**COMMISSION OF ARCHITECTURAL REVIEW
STAFF REPORT
May 22, 2018, Meeting**

14. **COA-034562-2018** (M. Elmes)

**130 N. 32nd Street
St. John's Church Old and Historic District**

**Demolish an existing garage and
Construct a new, 2-story frame garage.**

Figure 1: 1908 Sanborn Map

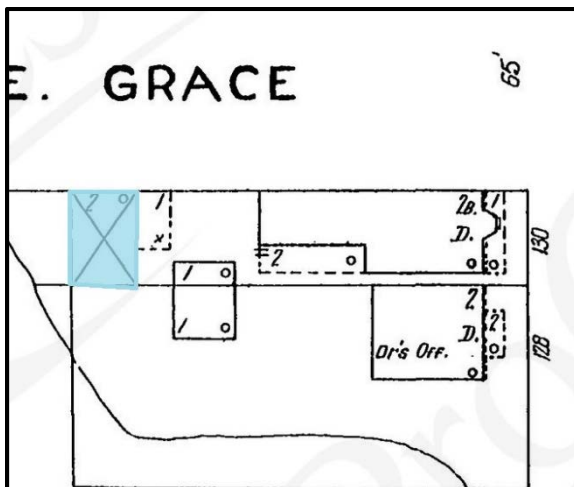
A dimensioned context elevation was not provided. The drawings provided show that that garage will be 18’ tall at the street face and 19’ on the yard side – an imperceptible slope from the street. The Sanborn Maps also suggest that there was a 2-story structure in this location in 1908.
